RE: Percolation Test Report; Nancy Griffin, Sands Property, Parcel 2, perc test results

RE: Sands Property, Par 2\_Bushy Park Road, perc cert comment

**PERC CERTIFICATION PLAN**  
**NANCY GRIFFIN**

The Bat Plan for the Griffin Property has been reviewed. Please address the following comments to this plan.

**PLOT PLAN**  
**GRIFFIN PROPERTY**  
**PARCEL 2**  
 TAX MAP 08 PARCEL 90  
 BLOCK 22  
 4TH ELECTION DISTRICT  
 HOWARD COUNTY, MARYLAND

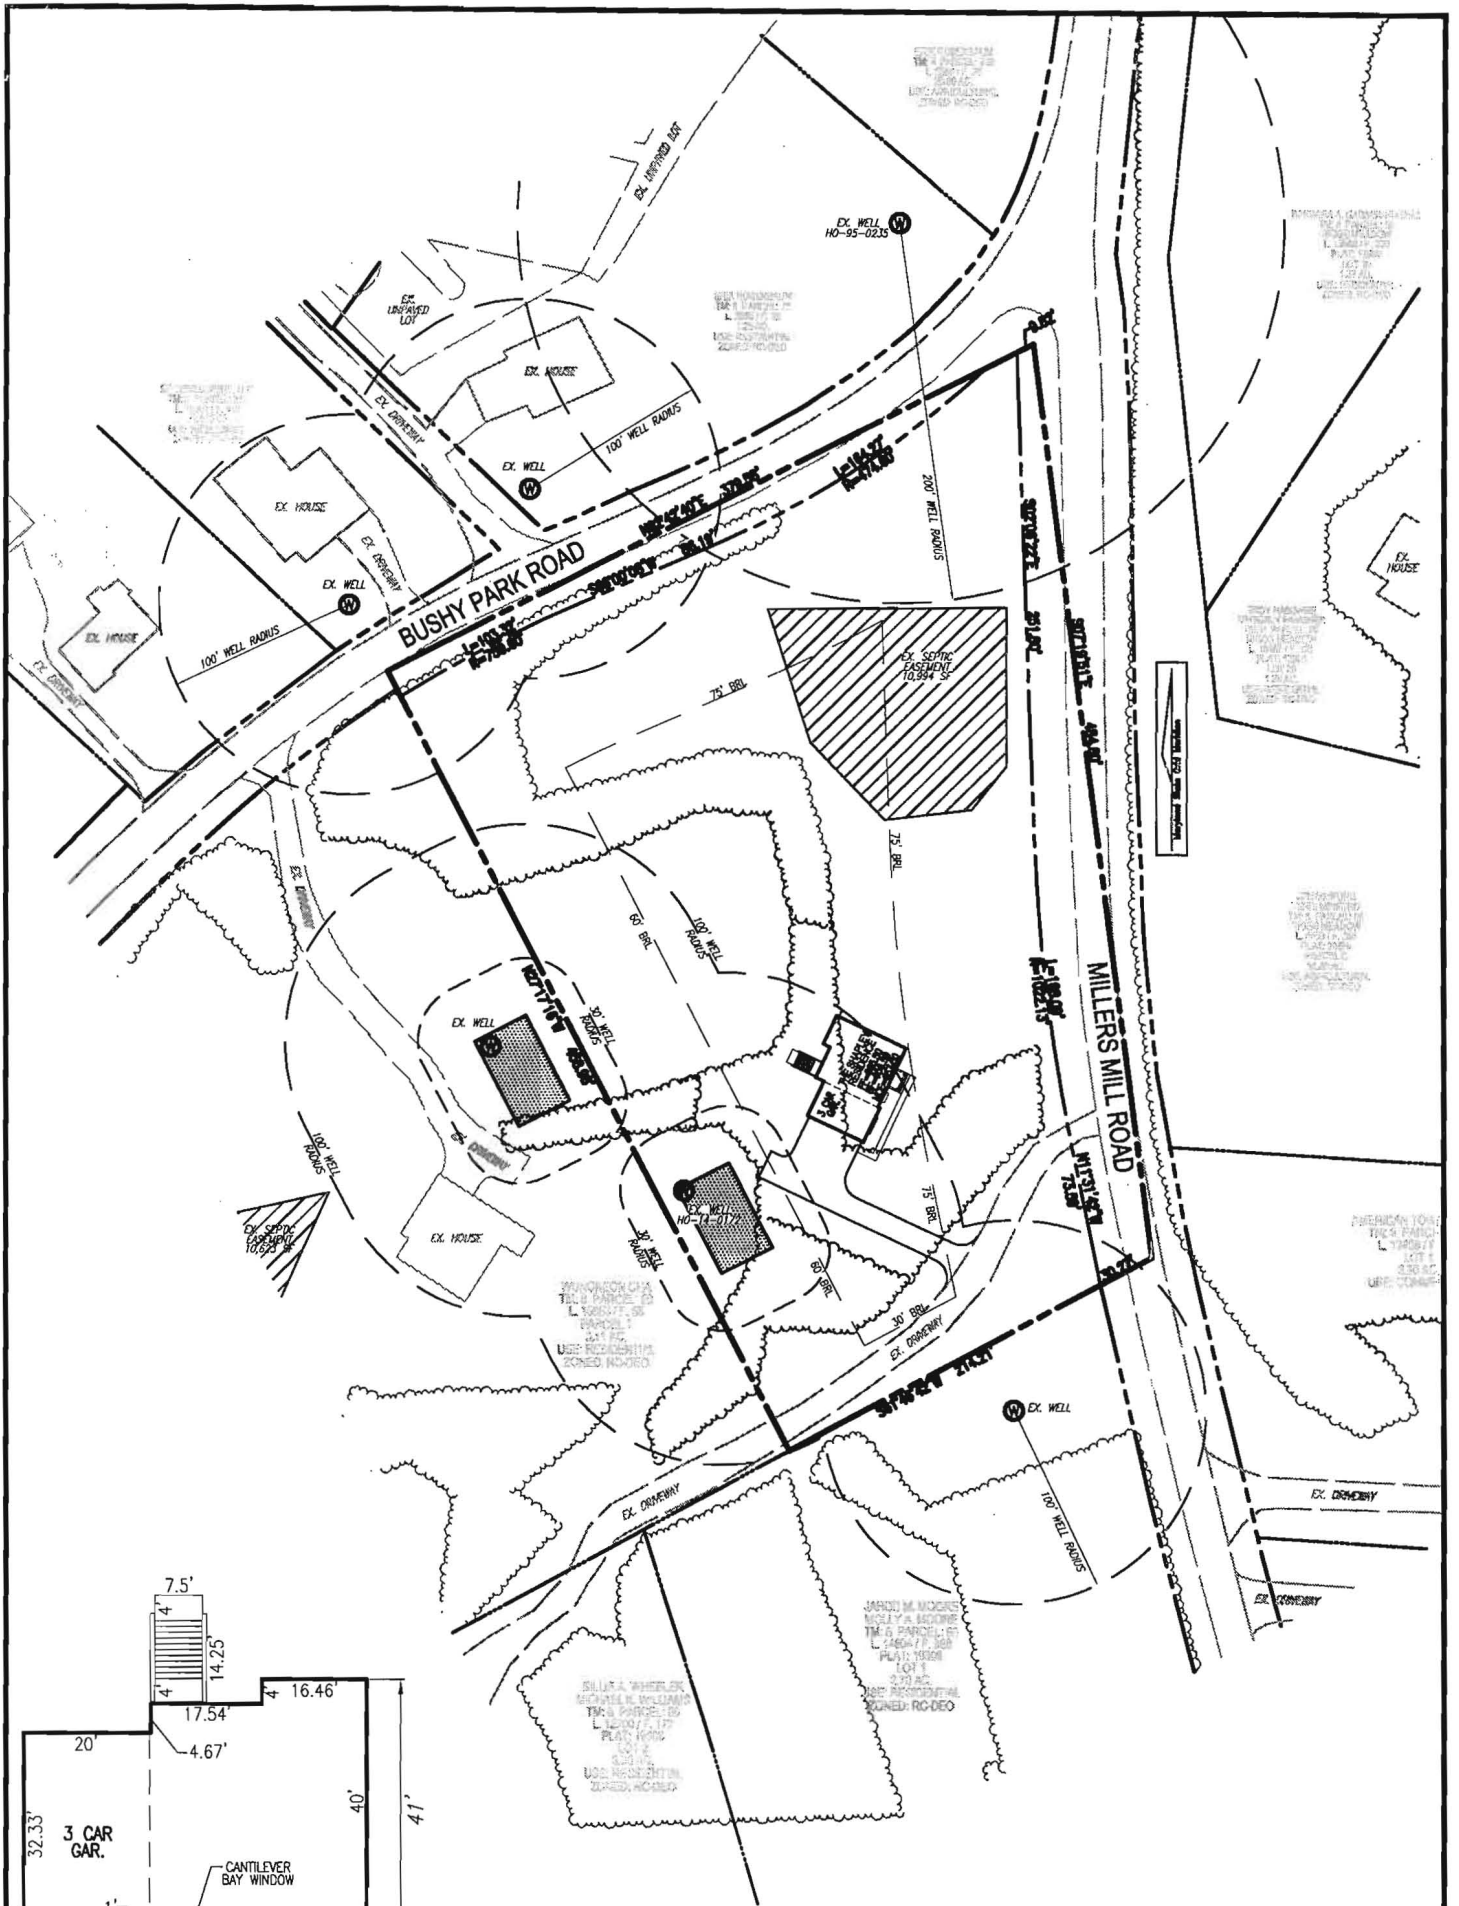
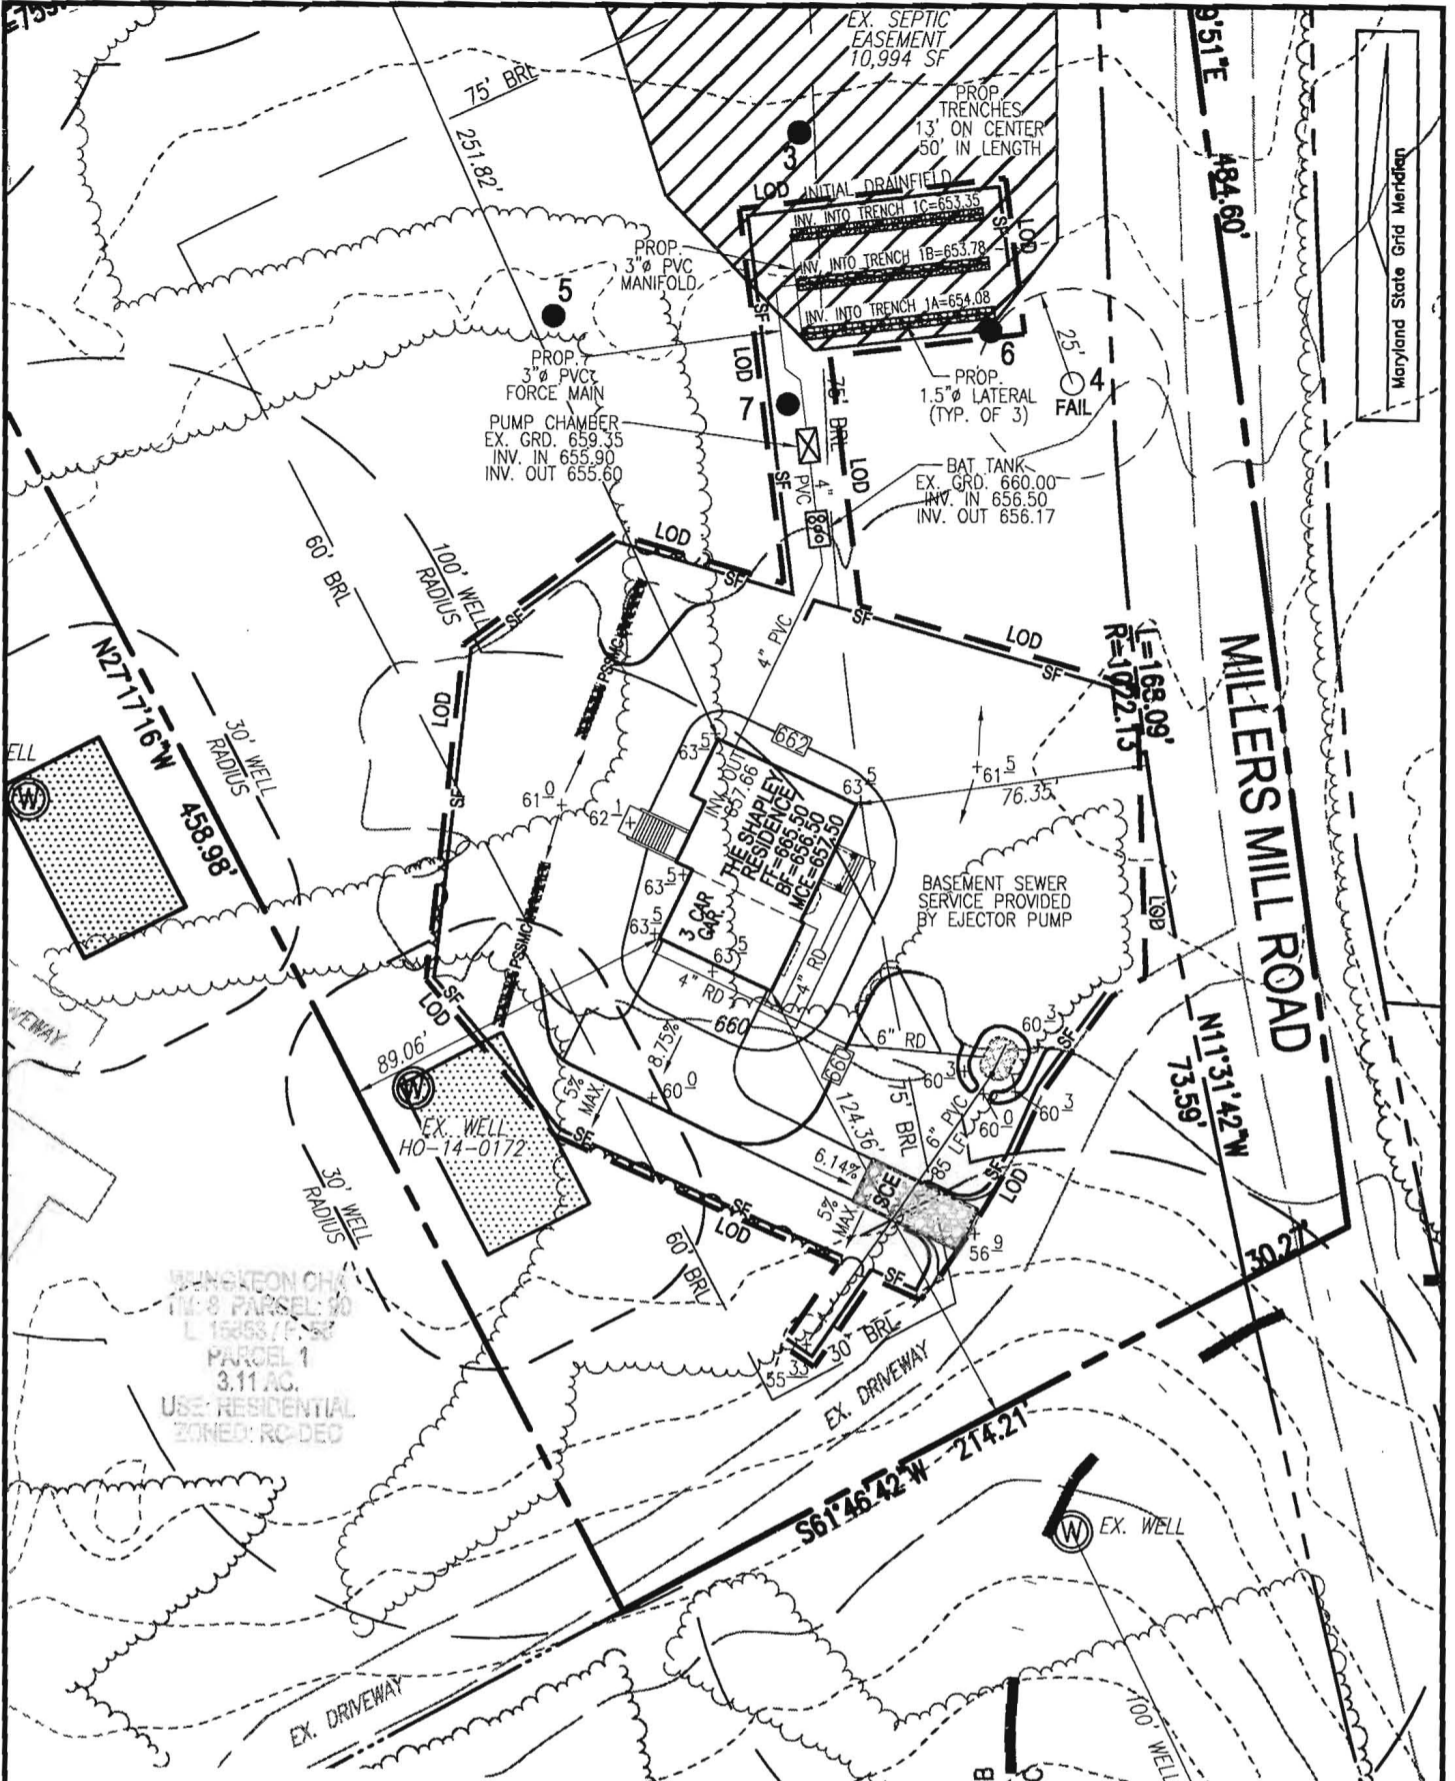
**Minimum Dose:** If the LDR is 50.9 then the volume per 100 feet in the lateral is 10.6 not 7.8. Additionally, the minimum dose should be 1/6th the design flow because its greater than the minimum dose of 102.6 (not 81.6) gallons min. dose. Therefore, the minimum dose should be 125 gallons. Please show those calculations on the plan ✓

**High Water Alarm and Pump On/Off Elevations:** Change as necessary based on the new dose

Show a chart with the following details for each lateral:

- Trench Length ✓
- Lateral Lengths ✓
- Hole Diameter ✓
- Hole Separation ✓
- # of holes ✓
- Discharge/Hole ✓
- Discharge/Lateral ✓
- Distal Head ✓
- Combine Trench Detail with chart (Please note: max invert depth is 4 feet so please make this change.) ✓

### 2.)Lateral Detail:

Show Pipe Turning up at the end (last 5.5 marker) with last hole at elbow. X

Show trench and proper spacing between lateral and end of trench. ✓

Revise statement to read, Turns Up See Detail not See Sand Mounds ✓

Add note that wells were field located. ?

1. The requested chart has been added to the plan.
2. The lateral detail has been revised as requested.
3. The BAT unit has been revised to the 500 gpd model. The lateral discharges do not match due to the slight change in lateral elevation and number of holes.
4. The static head has been revised accordingly.
5. The well location note has been added.

**PERC CERTIFICATION PLAN**  
**NANCY GRIFFIN**

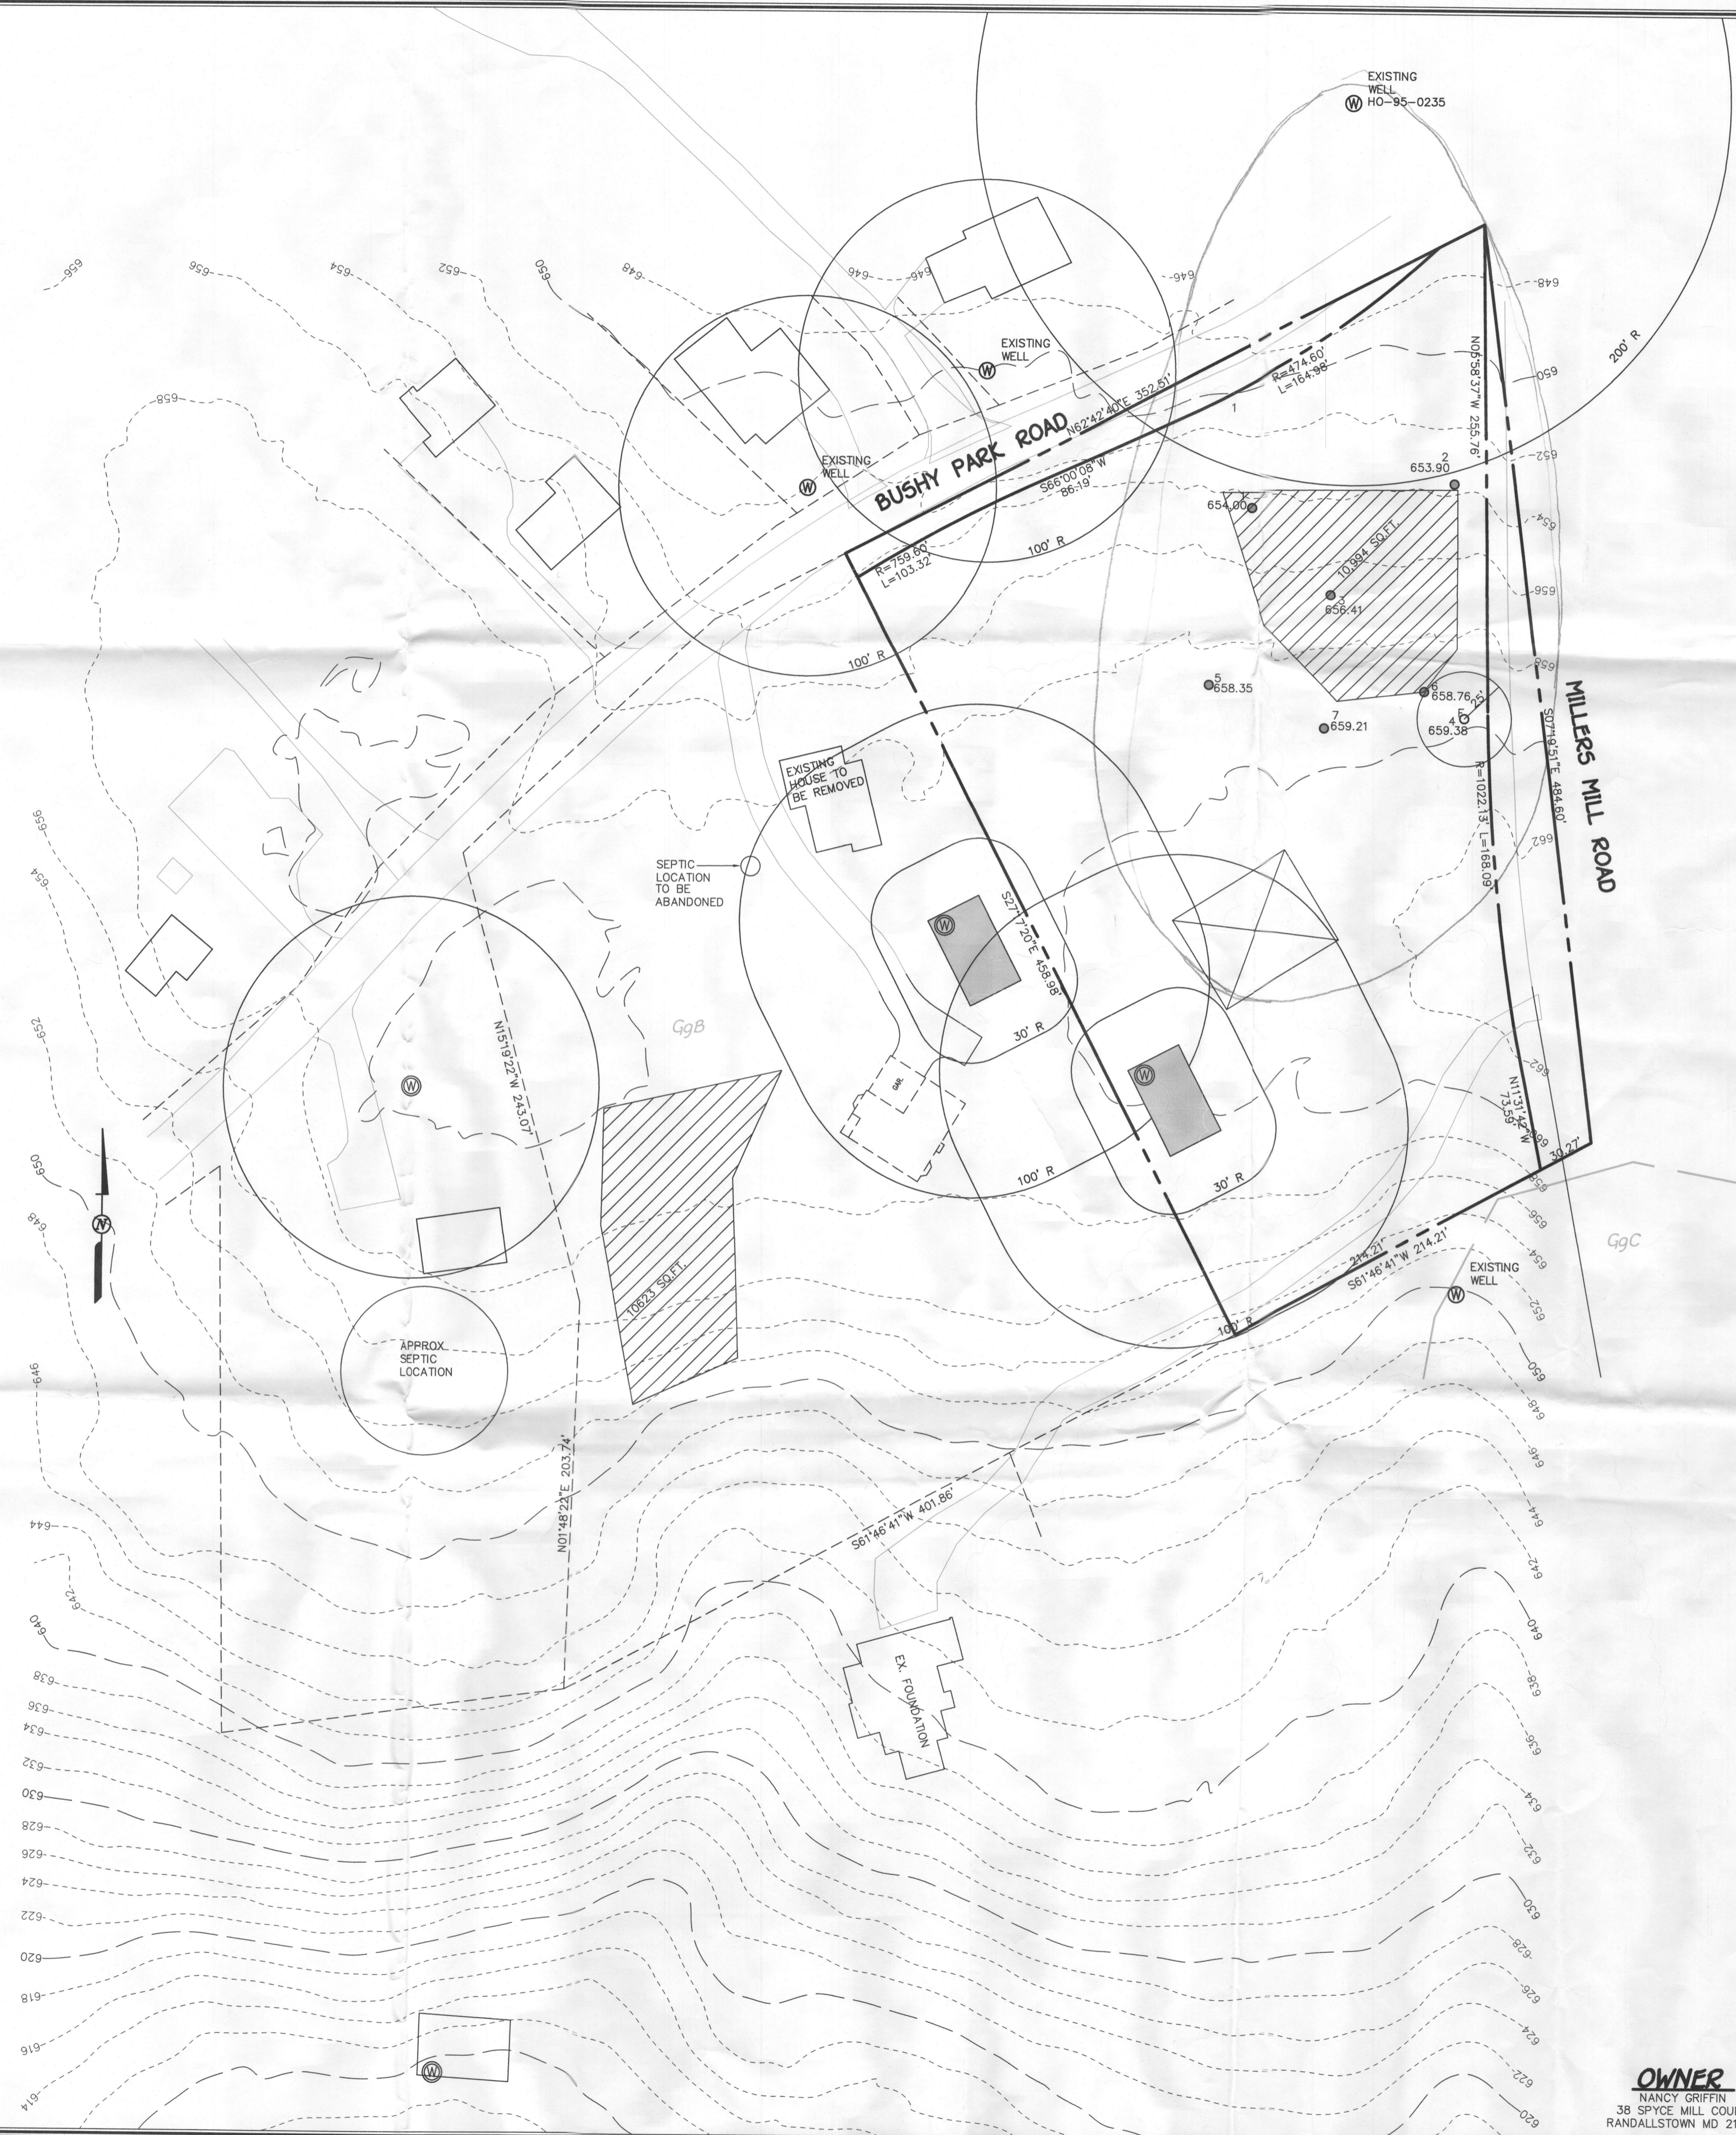
1. Adjust proposed sewage disposal area to avoid the condition of being upgrade of the well at 14806 Bushy Park Road. See attached graphic.
2. Add this Note :

THE WELL SHALL BE DRILLED PRIOR TO BUILDING PERMIT APPROVAL. IT IS THE DEVELOPER'S RESPONSIBILITY TO SCHEDULE THE WELL DRILLING PRIOR TO SUBMITTAL OF A BUILDING PERMIT. IT WILL NOT BE CONSIDERED "GOVERNMENT DELAY" IF THE WELL DRILLING HOLDS UP HEALTH DEPARTMENT SIGNATURE OF THE BUILDING PERMIT.

3. Add this Note:

THE MARYLAND DEPARTMENT OF THE ENVIRONMENT (MDE) HAS APPROVED A VARIANCE TO ALLOW THE SEWAGE DISPOSAL AREAS (SDA) ON THE SUBJECT PROPERTY (SANDS PROPERTY PAR. 2) TO BE UPGRADIENT OF WELL HO-95-0235 WHICH IS AT 14790 BUSHY PARK ROAD (SUN NURSERIES, INC.) THIS APPROVAL BY MDE IS GRANTED PURSUANT TO THE FOLLOWING CONDITIONS:

1. THE SEPTIC SYSTEM INSTALLED ON THE SUBJECT PROPERTY MUST INCLUDE A BEST AVAILABLE TECHNOLOGY (BAT) UNIT.
2. ALL SEPTIC SYSTEM DRIANFIELDS ON THE SUBJECT PROPERTY MUST BE DESIGNED FOR PRESSURE DISTRIBUTION OR EQUIVALENT.

8. ANY CHANGES TO A PRIVATE SEWERAGE EASEMENT SHALL REQUIRE A REVISED PERC CERTIFICATION PLAN.
9. DEED REFERENCE LIBER 13048 FOLIO 87.
10. THE WELL SHALL BE DRILLED PRIOR TO BUILDING PERMIT APPROVAL. IT IS THE DEVELOPER'S RESPONSIBILITY TO SCHEDULE THE WELL DRILLING PRIOR TO SUBMITTAL OF A BUILDING PERMIT. IT WILL NOT BE CONSIDERED "GOVERNMENT DELAY" IF THE WELL DRILLING HOLDS UP HEALTH DEPARTMENT SIGNATURE OF THE BUILDING PERMIT.

11. THE MARYLAND DEPARTMENT OF THE ENVIRONMENT (MDE) HAS APPROVED A VARIANCE TO ALLOW THE SEWAGE DISPOSAL AREAS (SDA) ON THE SUBJECT PROPERTY (SANDS PROPERTY PAR. 2) TO BE UPGRADIENT OF WELL HO-95-0235 WHICH IS AT 14790 BUSHY PARK ROAD (SUN NURSERIES, INC.) THIS APPROVAL BY MDE IS GRANTED PURSUANT TO THE FOLLOWING CONDITIONS:

1. THE SEPTIC SYSTEM INSTALLED ON THE SUBJECT PROPERTY MUST INCLUDE A BEST AVAILABLE TECHNOLOGY (BAT) UNIT.
  2. ALL SEPTIC SYSTEM DRIFTFIELDS ON THE SUBJECT PROPERTY MUST BE DESIGNED FOR PRESSURE DISTRIBUTION OR EQUIVALENT.
